CITY OF GLENDALE, CA

DESIGN REVIEW STAFF REPORT – SINGLE FAMILY

June 30, 2025 <i>Decision Date</i>	5008 Acampo Avenue, Glendale, CA 91214 <i>Address</i>
Administrative Design Review (ADR) <i>Review Type</i>	5601-003-033 <i>APN</i>
PDR 004626-2025 <i>Case Number</i>	David Law <i>Applicant</i>
Paulina Safarian, Associate Planner <i>Case Planner</i>	Kyle Kodani <i>Owner</i>

KODANI RESIDENCE
5008 Acampo Avenue,
Glendale, CA 91214

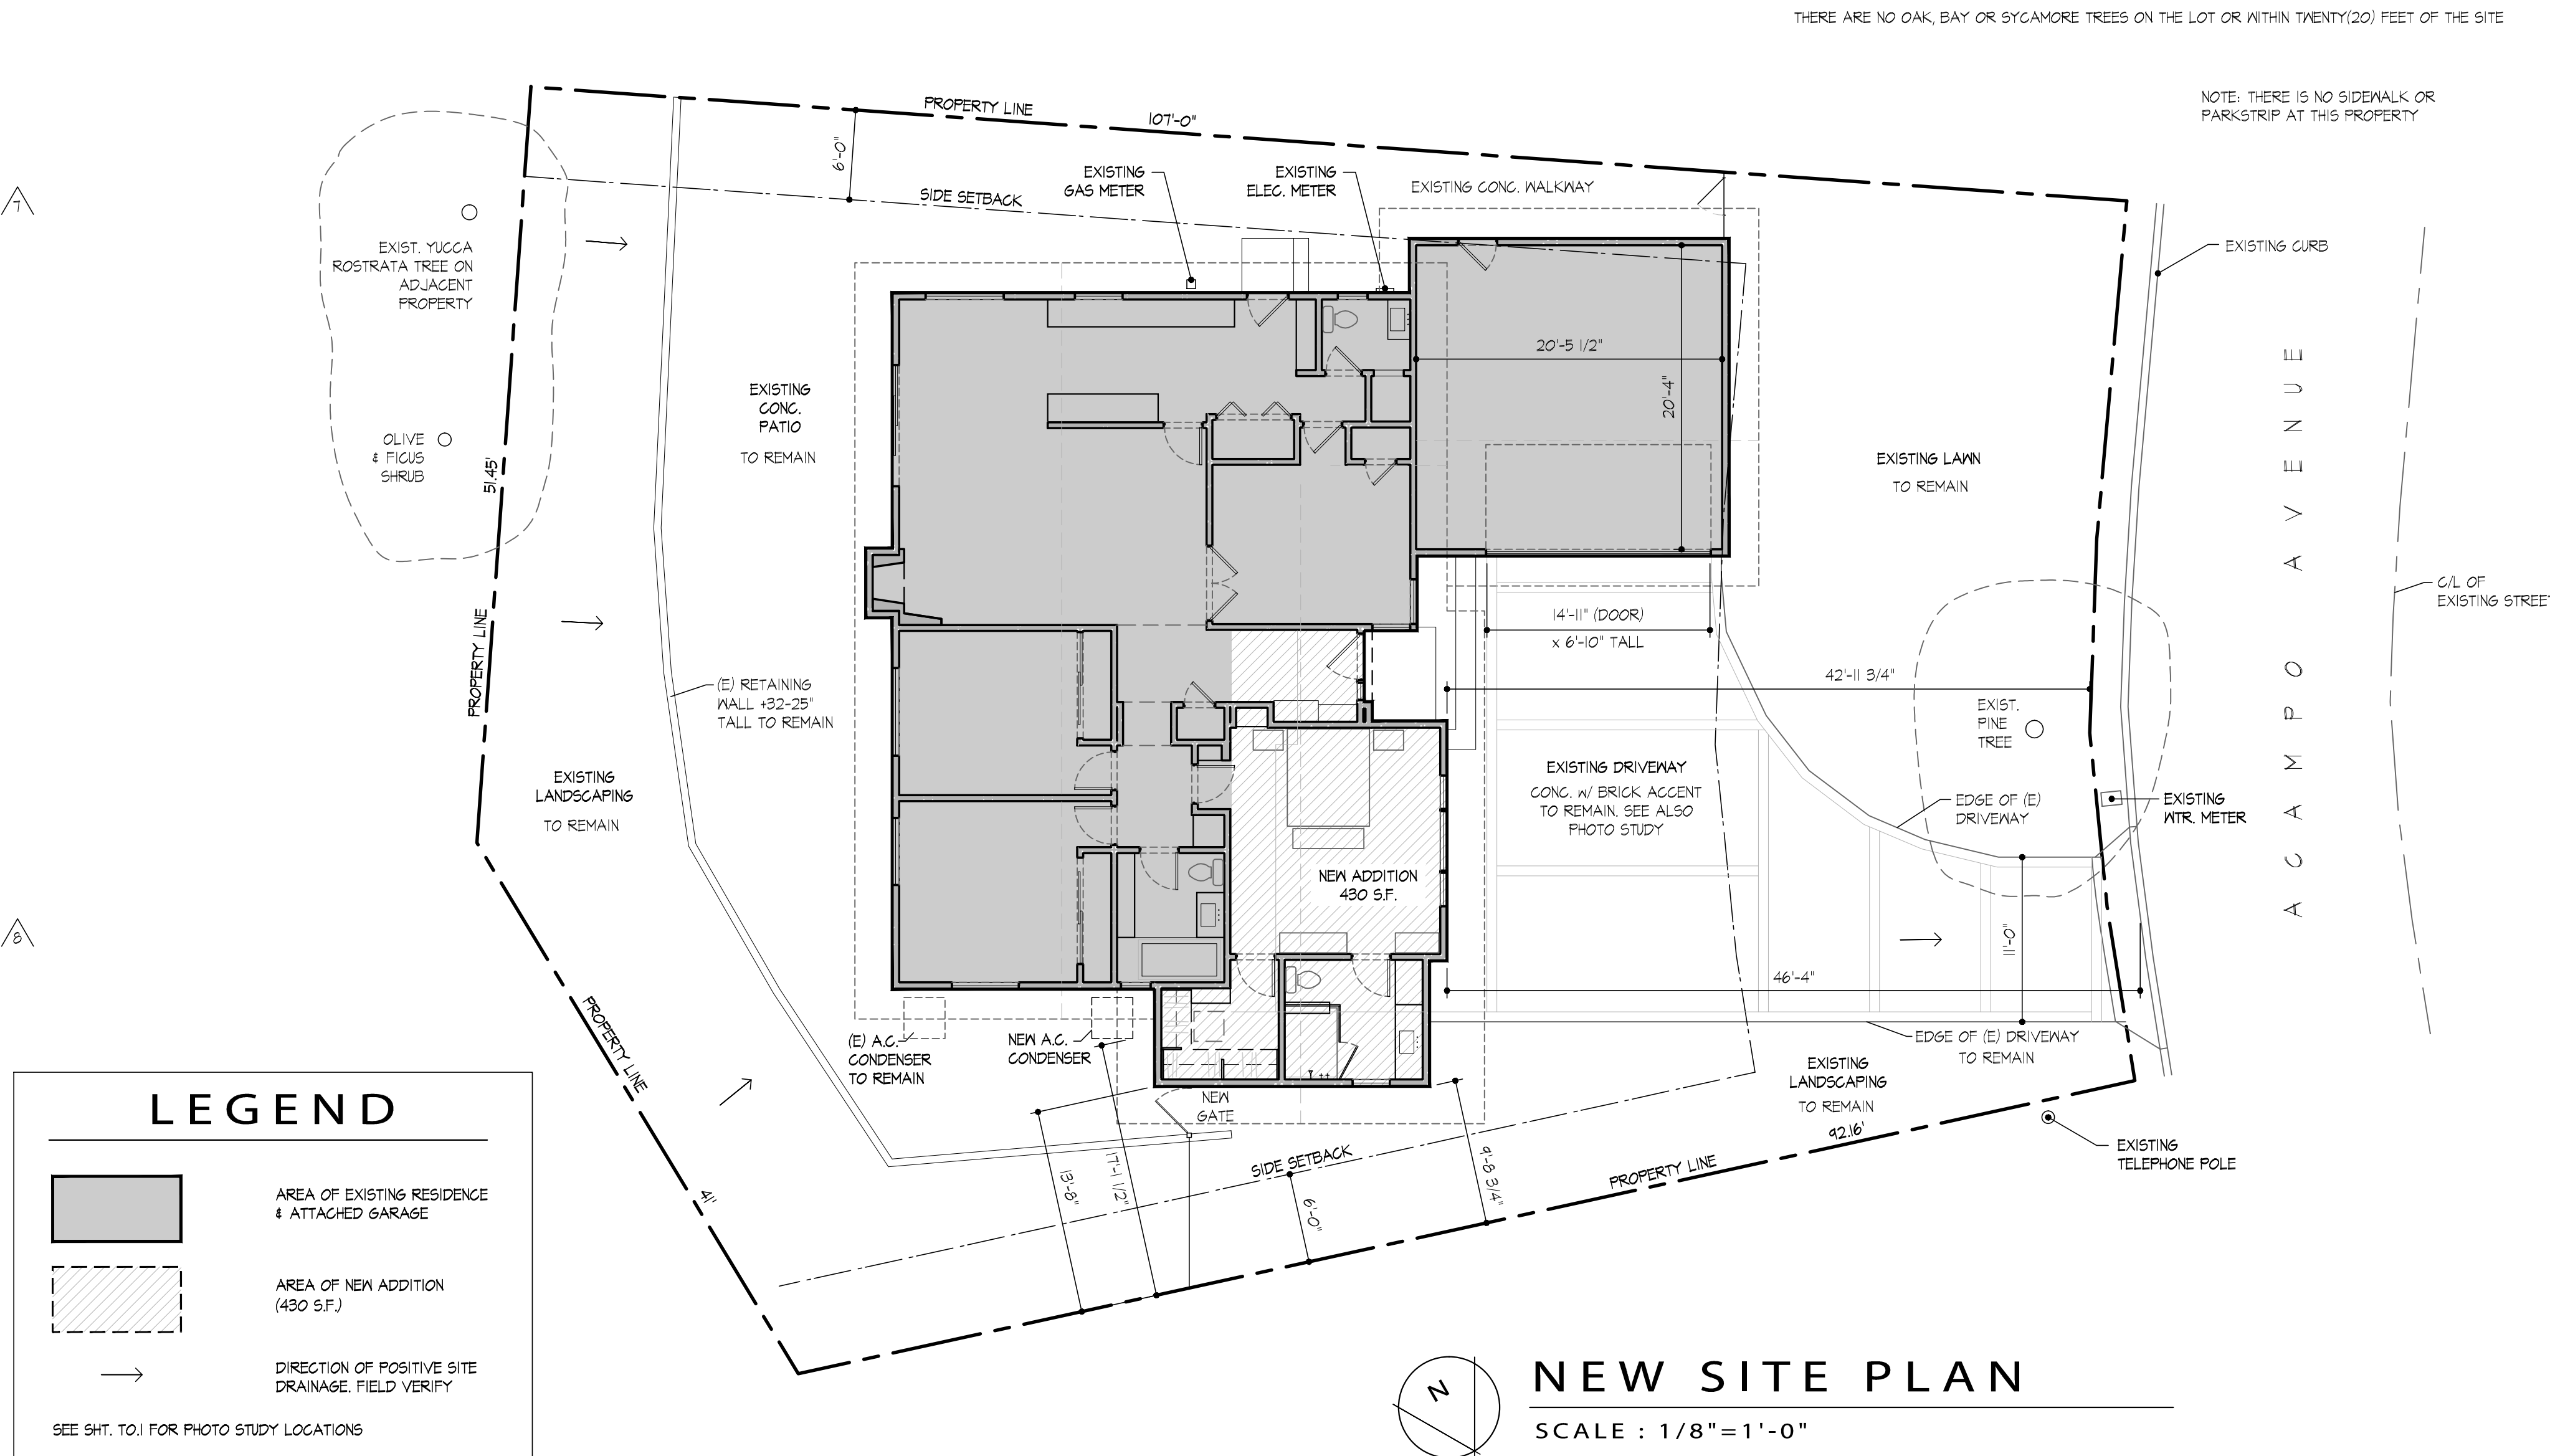
The drawings identify a new gate along the northern property line, and is appropriately located. No other information is provided regarding the design or material and staff is recommending a condition of approval that the applicant submit a detail of the gate design for staff review and approval.

No information is provided on the drawings related to exterior lighting and downspouts on the site or the building façade. Staff is recommending a condition of approval that the applicant submit a lighting plan and details including downspouts for staff review and approval. Trash bin location is not identified on plans. Staff recommends a condition to identify and appropriate trash area on the plans (e.g., at the northern side yard behind the new gate, not encroaching into the setback area and not visible from public street view).

1. The applicant shall comply with all of the recommendations identified in the Urban Forestry Department Comments dated June 16, 2025.
 2. That specifications (cut sheets) for the new side entry gate design be submitted for staff review and approval.
 3. That site light and the exterior light fixtures on the house and locations shall be submitted to staff for review and approval prior to plan check submittal. The exterior lighting should be appropriate to and consistent with the style of the house; limit their location to the main entry and patio doors. Label gutters and downspouts on the elevations and paint gutters to match the adjacent wall color. Also, identify trash area location on the site plan for staff review and approval.
-

**NEW FLOOR PLAN**

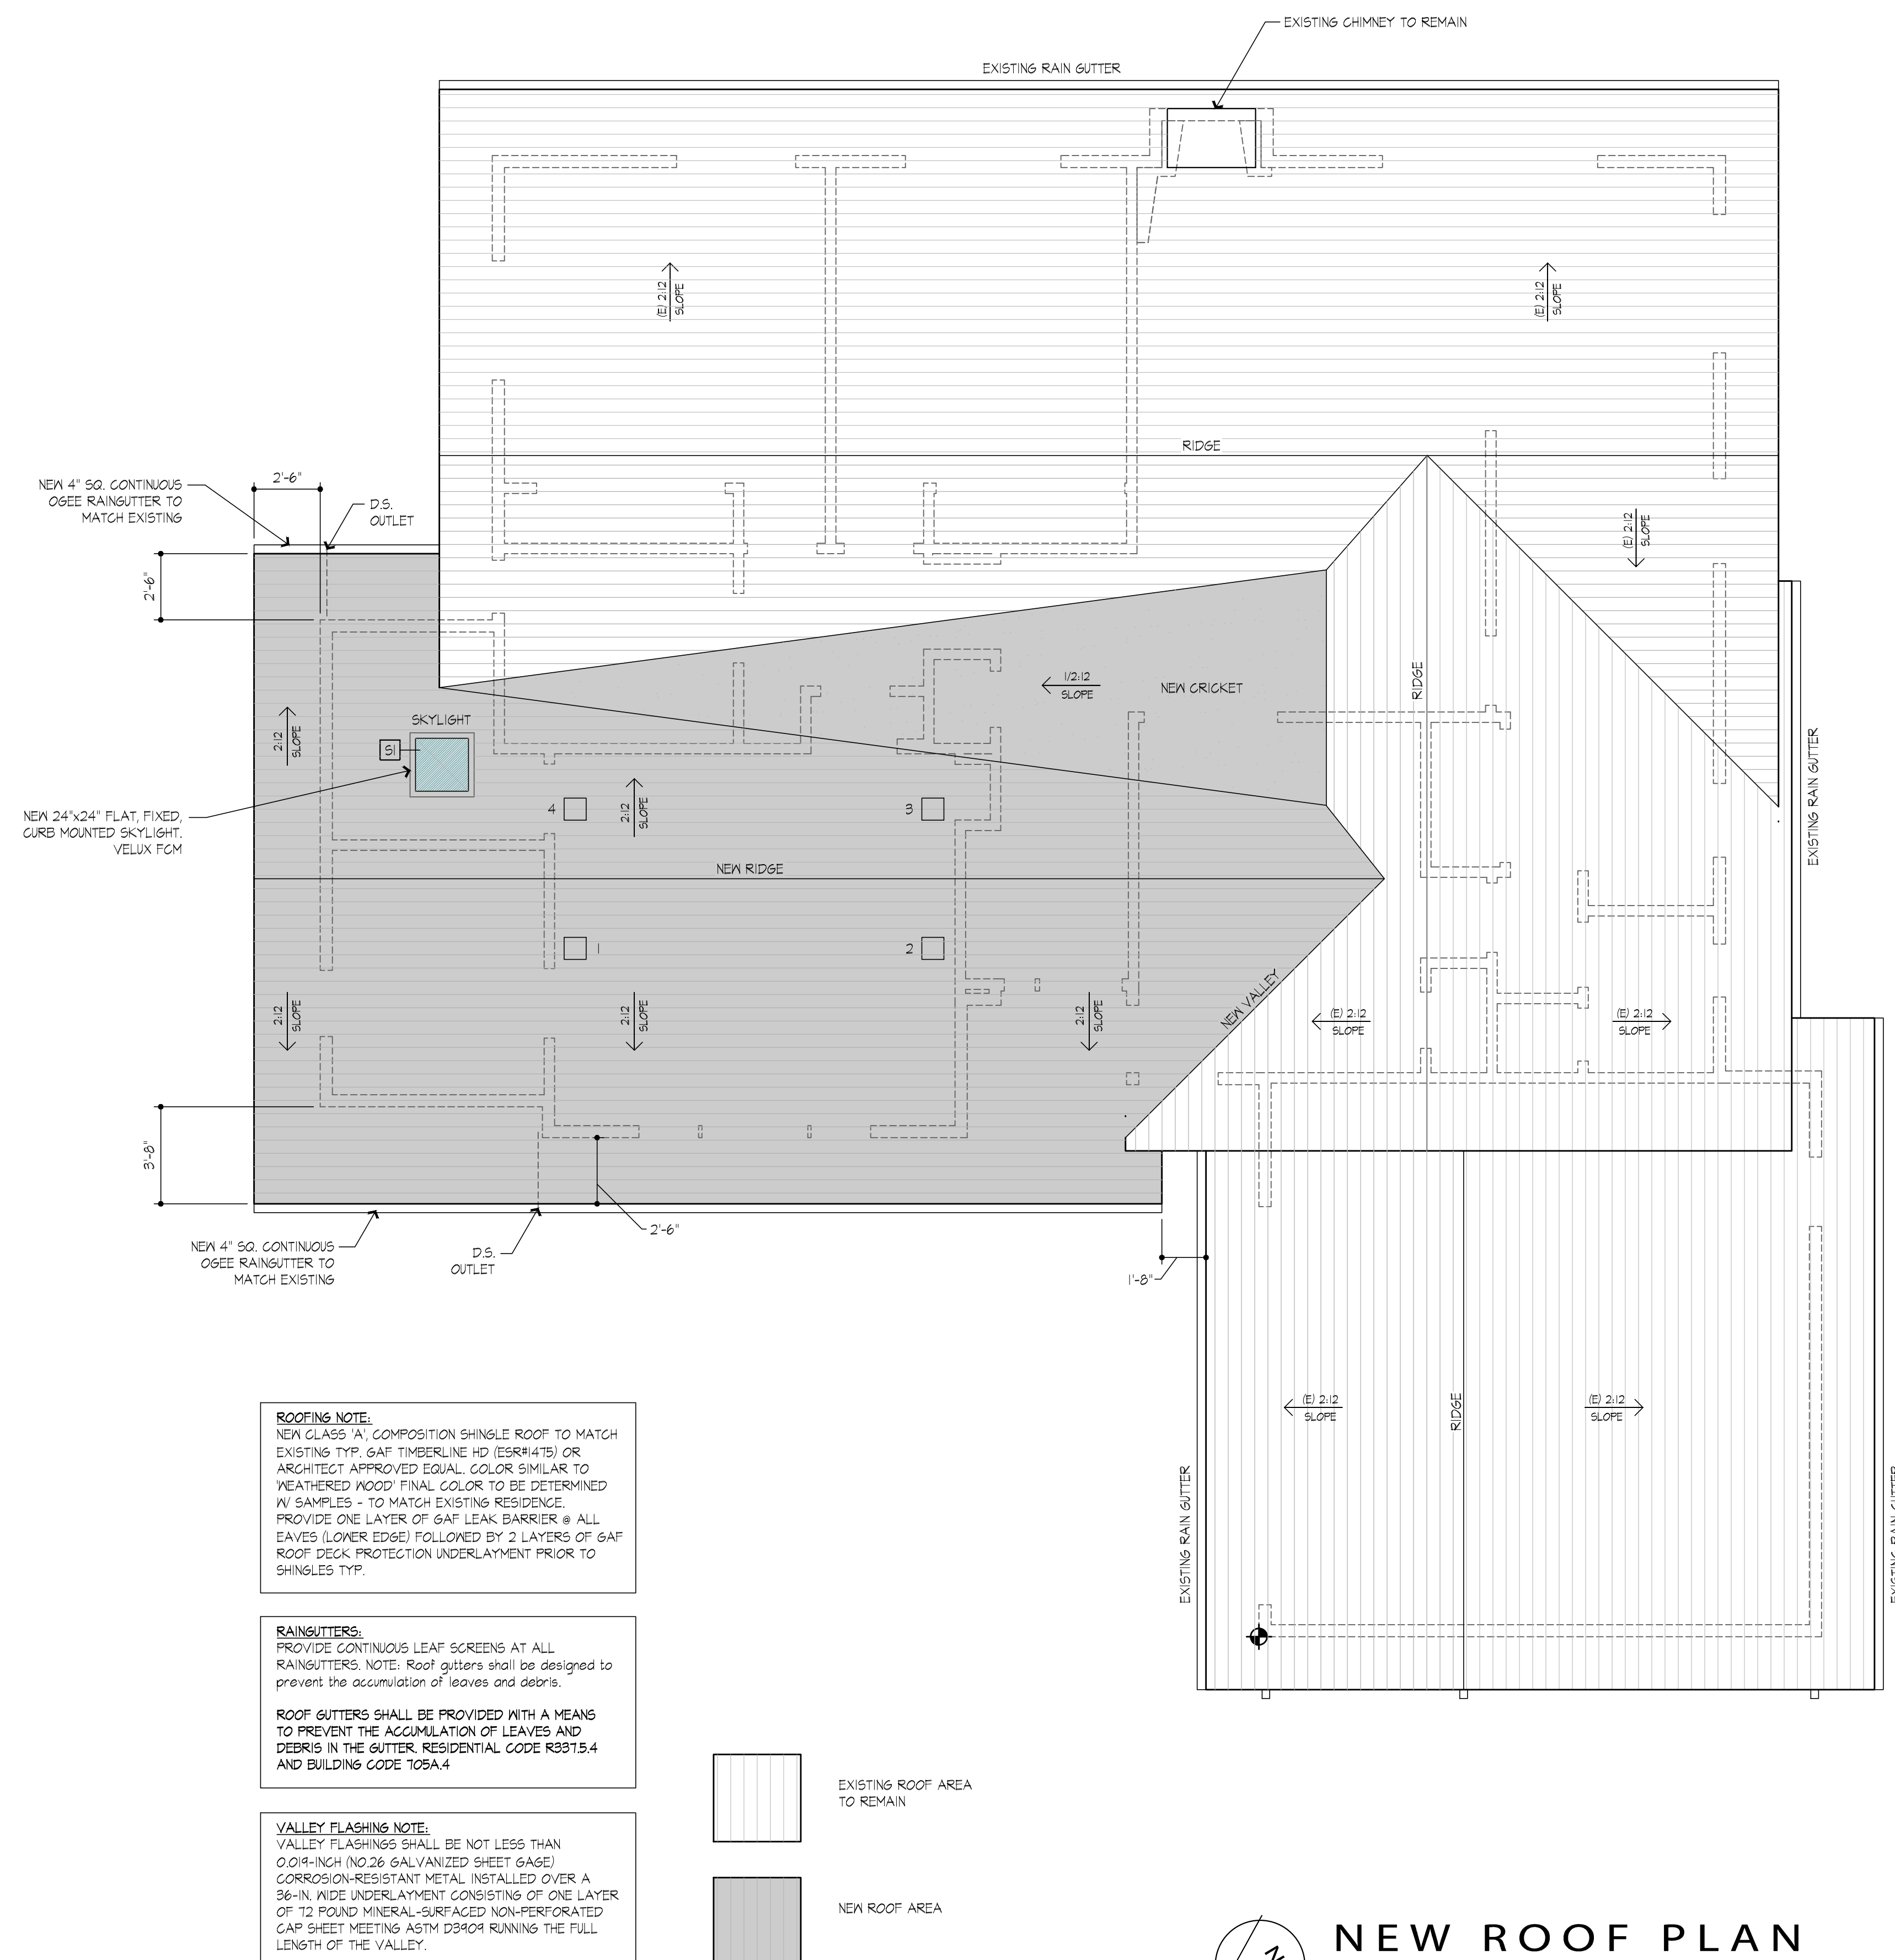
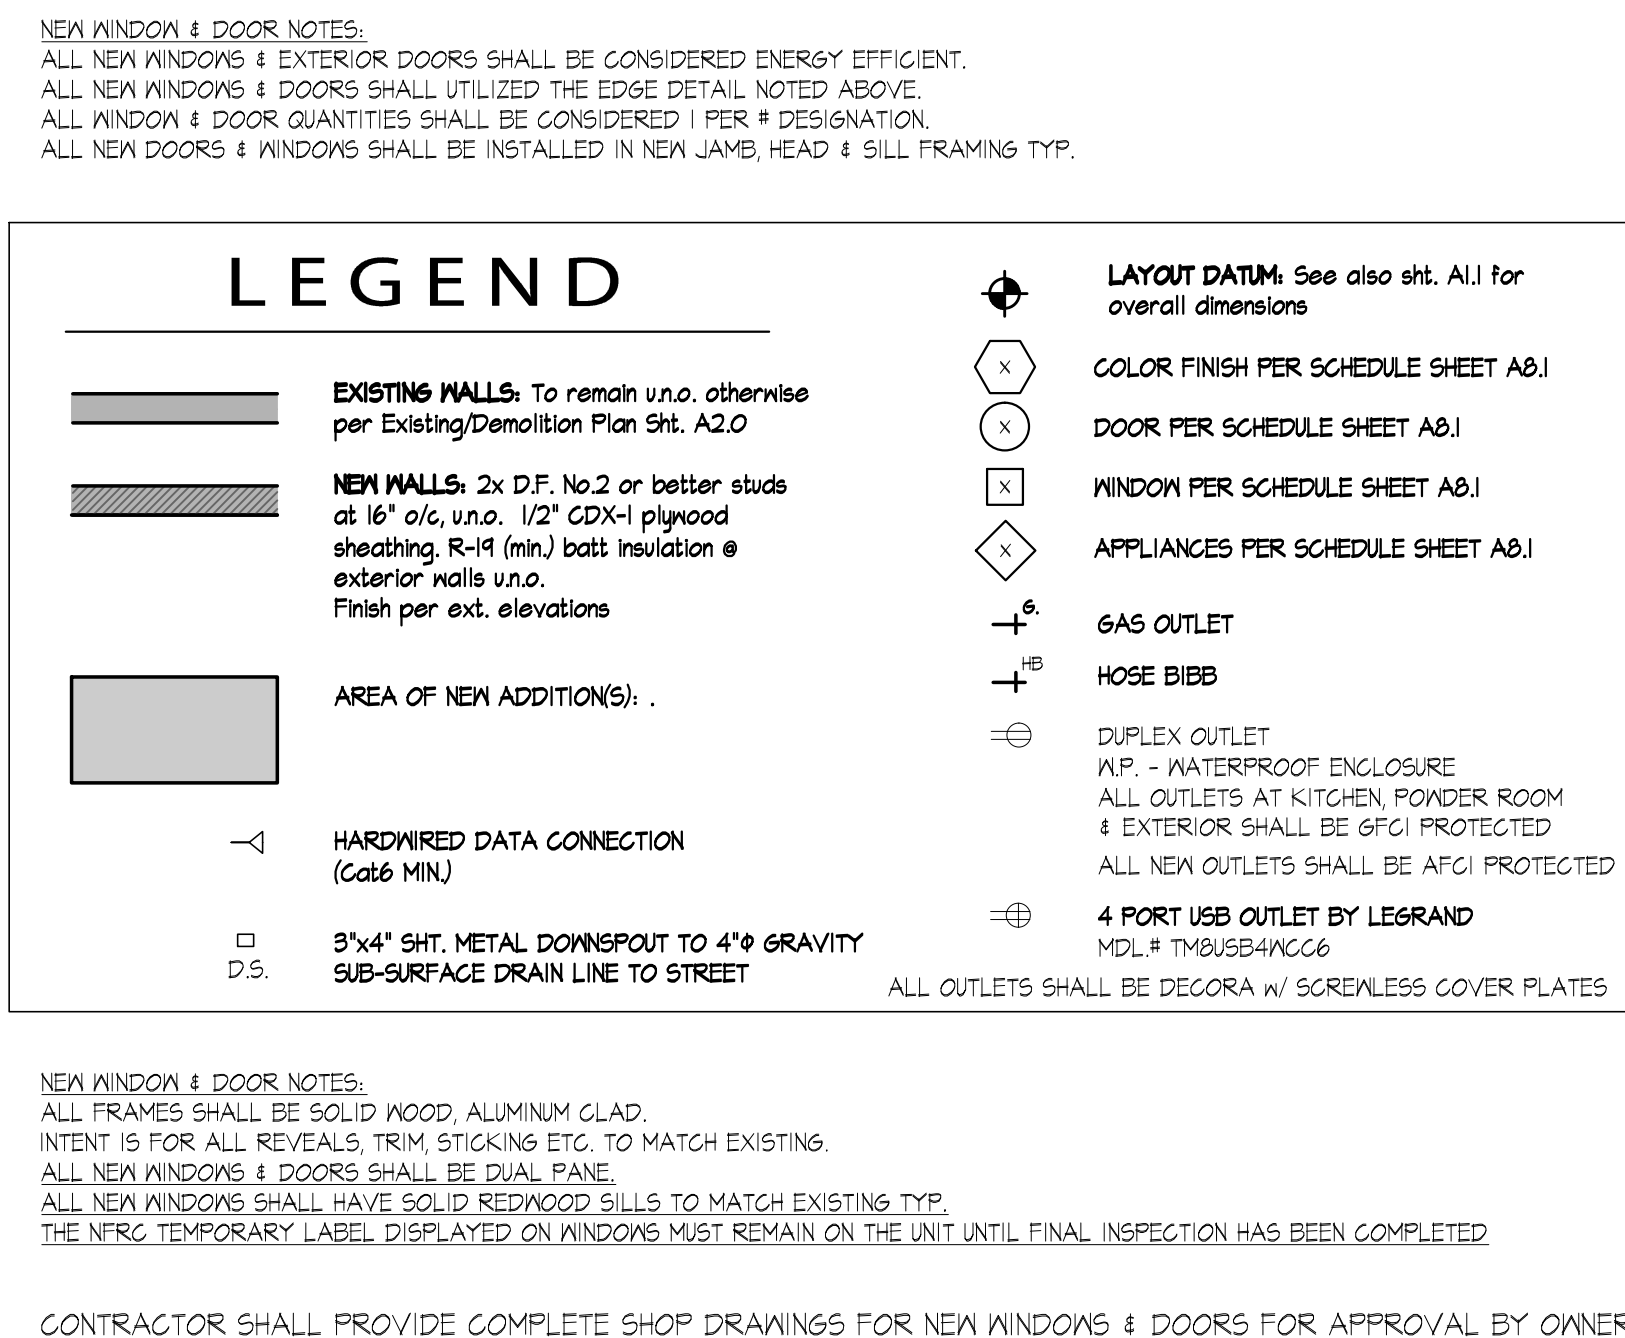
- The new windows are aluminum clad, nail-in frame, and an appropriate combination of casement, hung, and fixed operation. The windows will be recessed in the opening with a wood frame and sill to match the traditional style of the residence. Overall, the proposed windows are appropriate to the buildings in in terms of its style, material, operation and installation.
